Riverside Station

Response to Woodland Golf Club Comment Letter

June 19, 2020

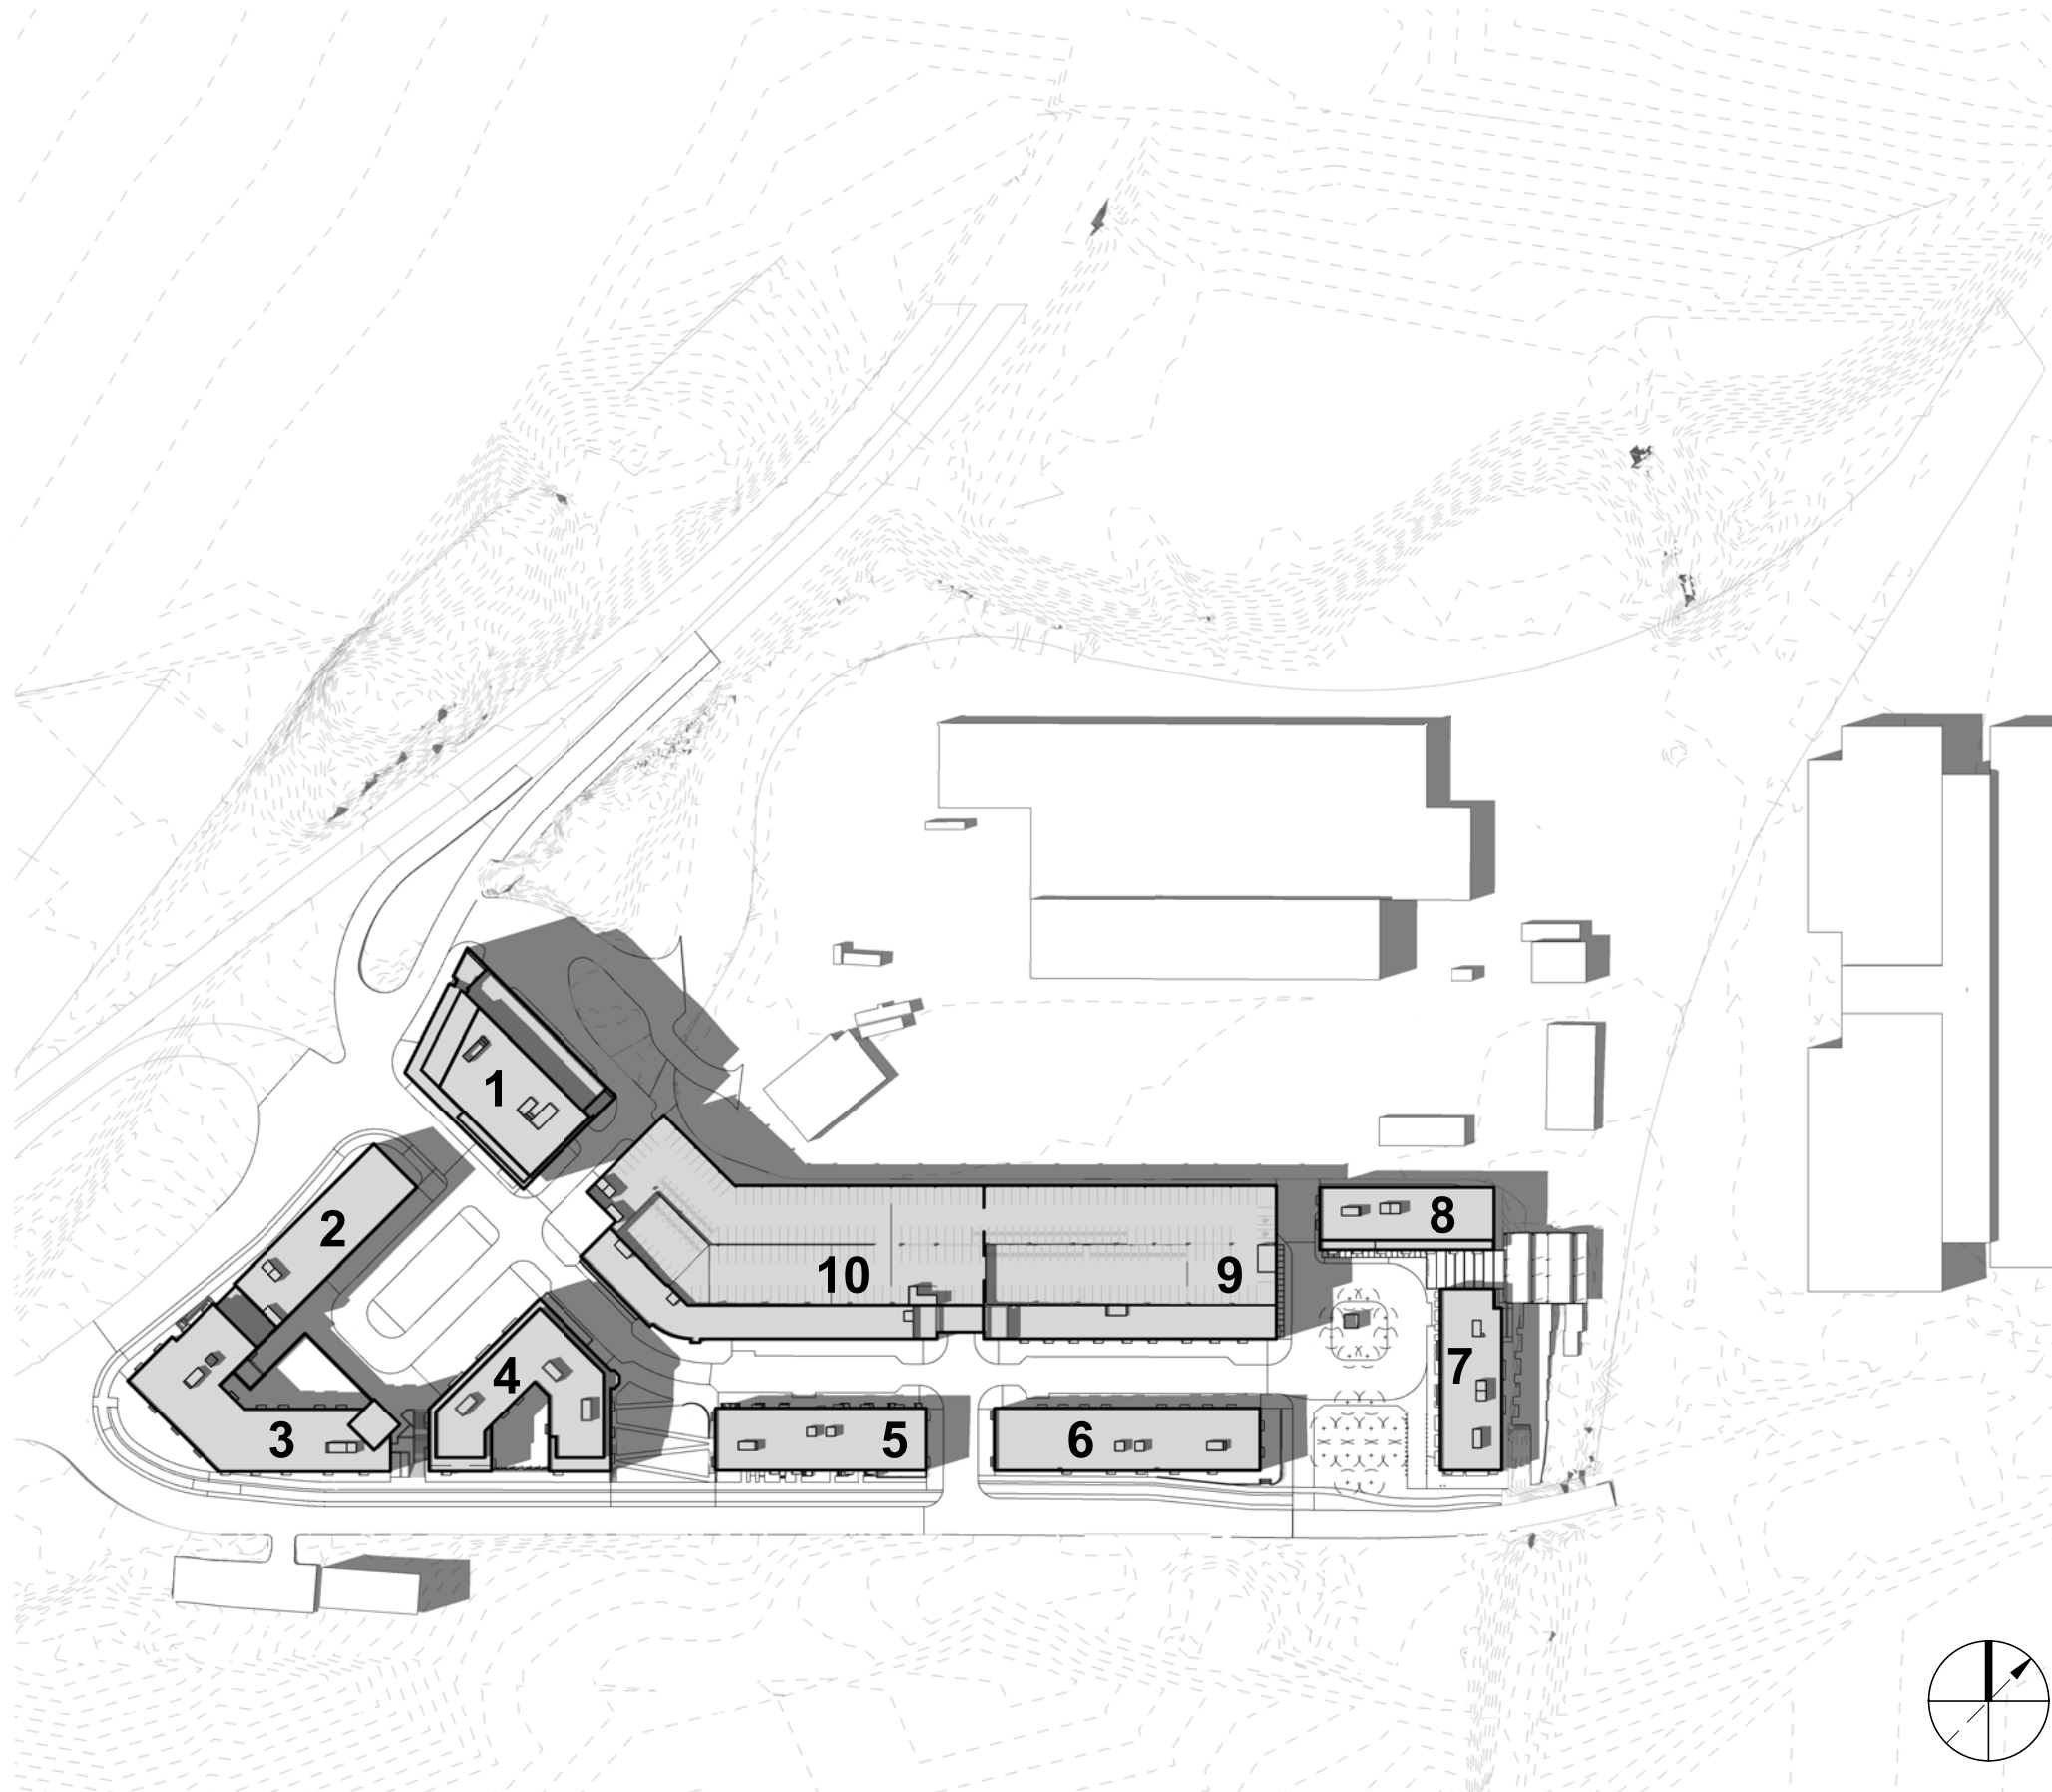
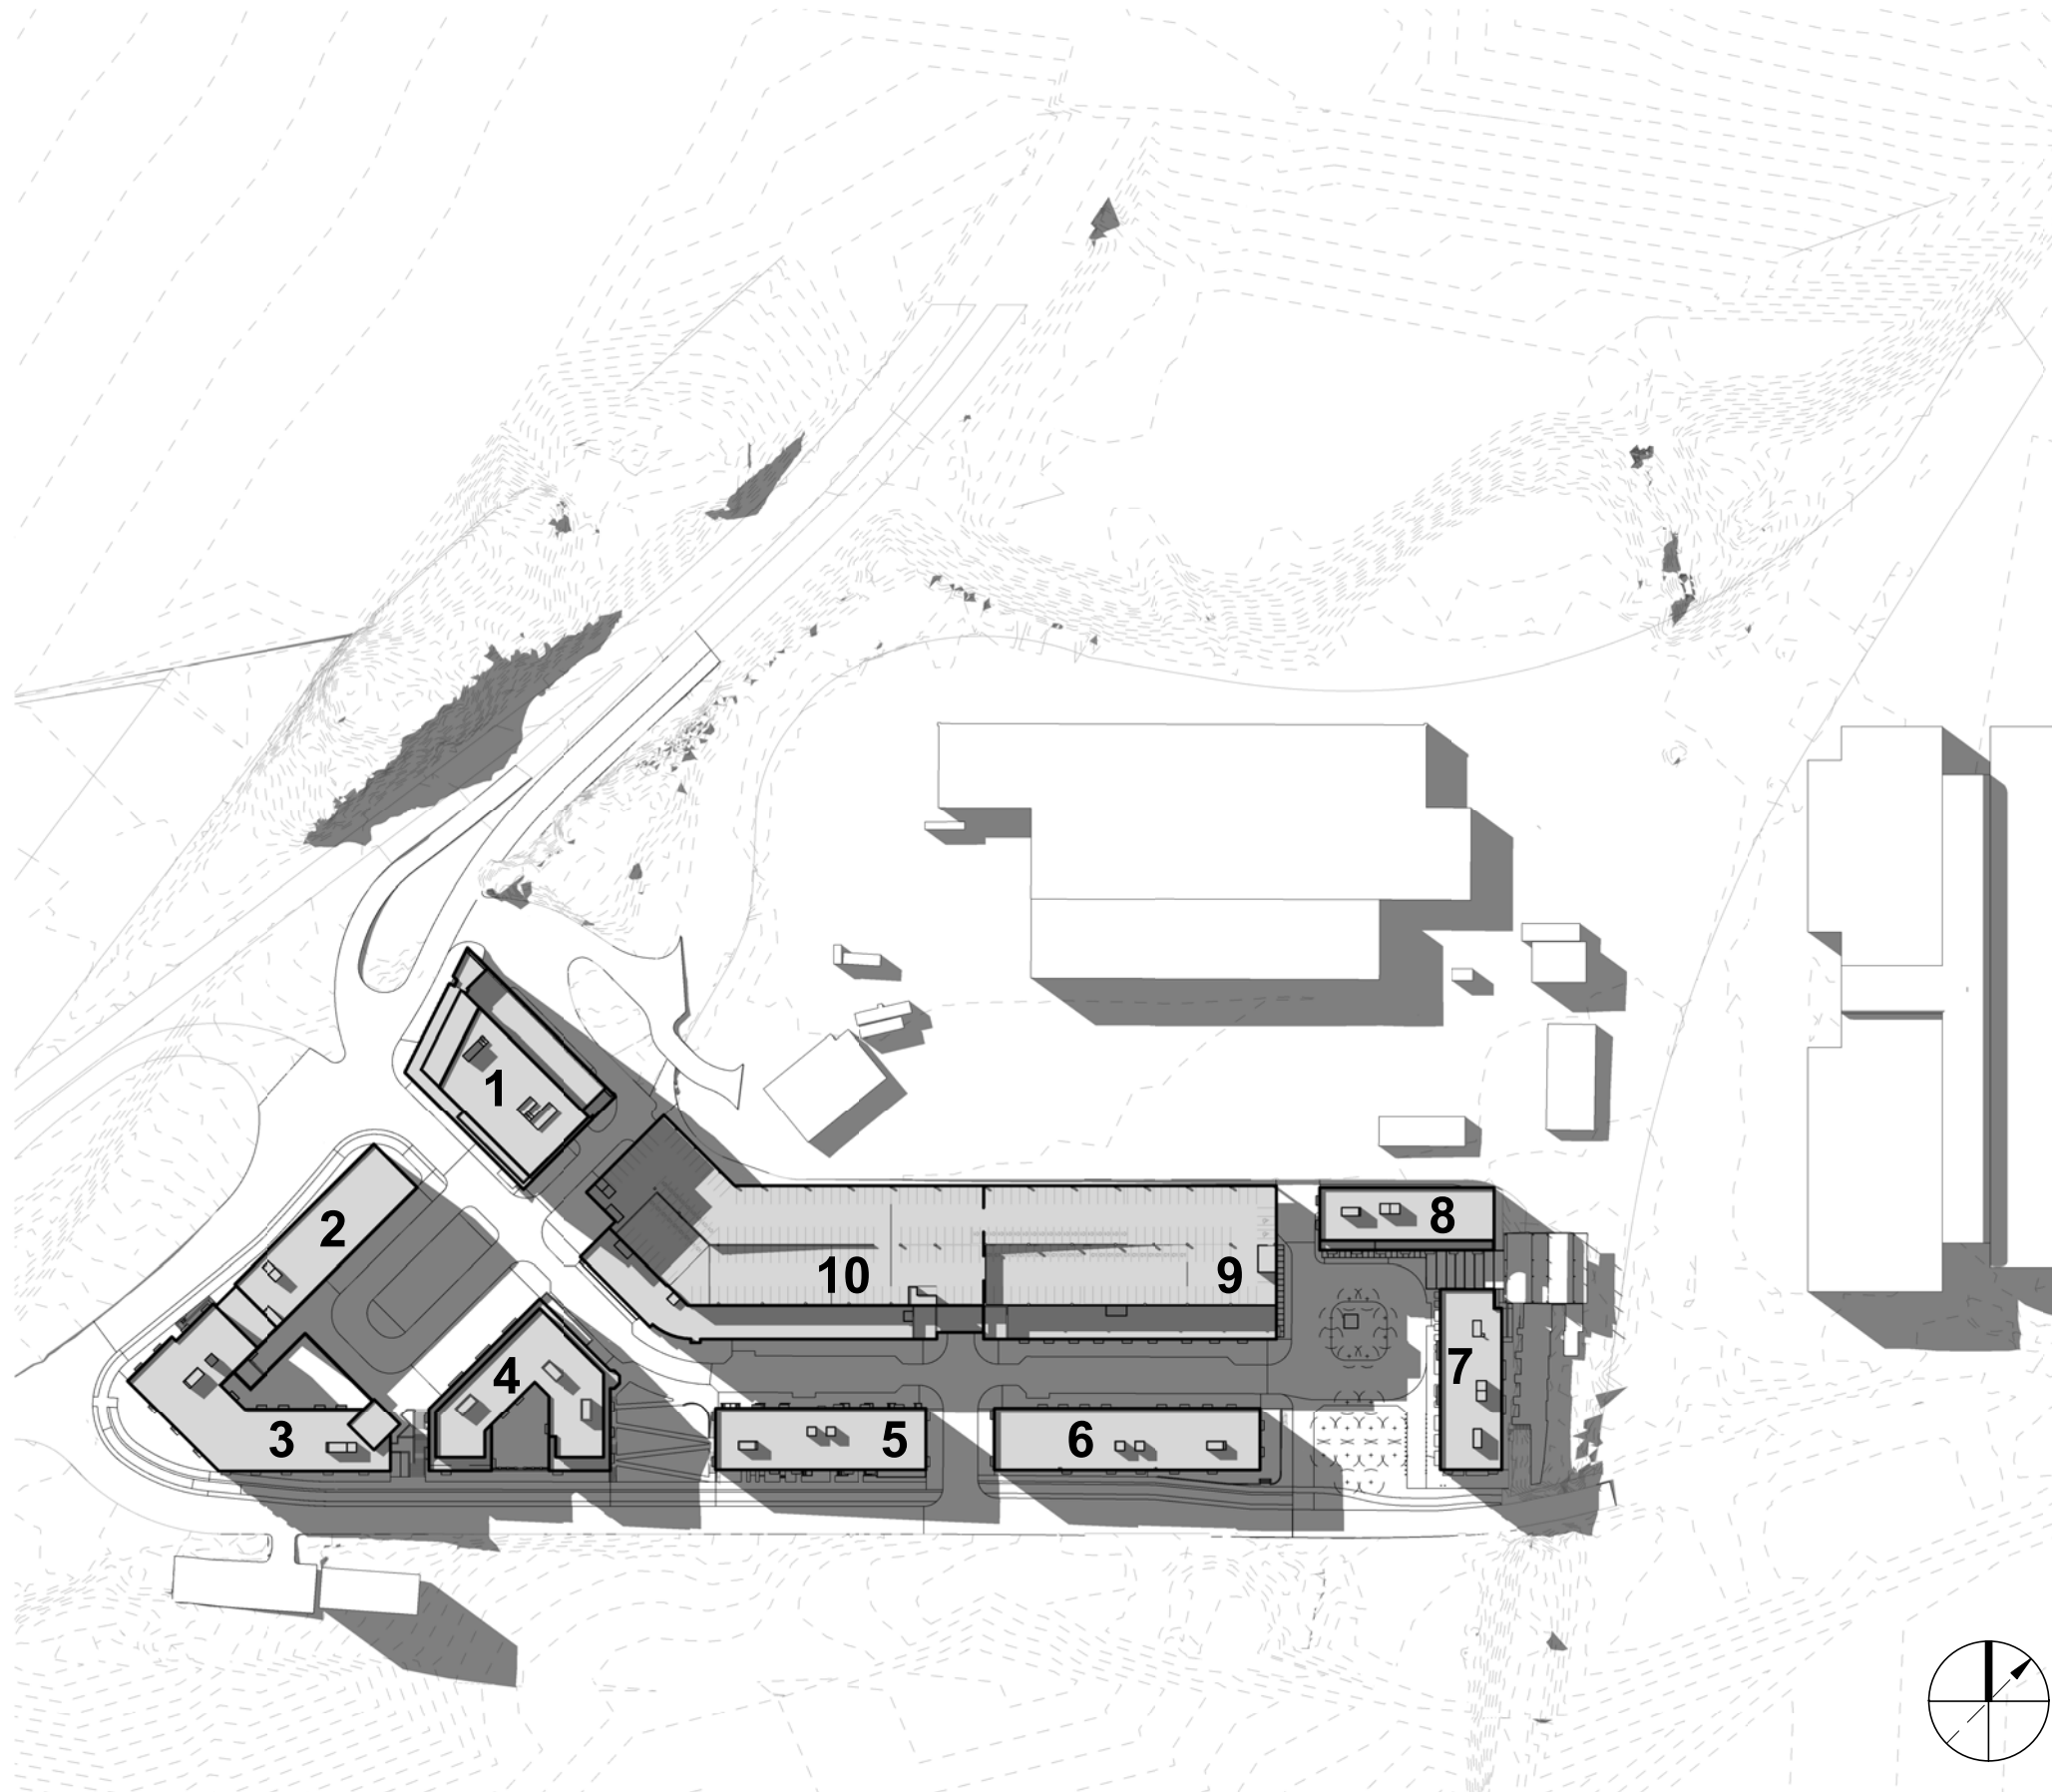
Woodland is also concerned that certain environmental impacts from the Project on the golf course have not been discussed nor has the mitigation of those impacts. Specifically, Woodland is concerned about the impact of shadows from the buildings on the greens, fairway, and related vegetation on the golf course. There does not appear to be any information on how the proposed buildings and their associated shadows may alter sunlight the golf course currently receives under the existing condition of parking lots on the Project site. The Applicant should address the impact of shadows on the greens, fairway, and vegetation on the golf course.

A shadow study has been included in the project plans on file. They are also attached for reference. This analysis concludes that during the Spring, Summer and Fall months, from 9AM to 3PM the project will not cast any shadows on the course. The shorter buildings along Grove Street will cast a slight shadow into the rough adjacent to the 5th hole at their peak on December 21st. This shadow is less impactful than that of the existing condominium. This slight shadow does not appear to approach the fairway, tee box, greens or cart paths in the event someone was on the course at this time of year, which is unlikely.
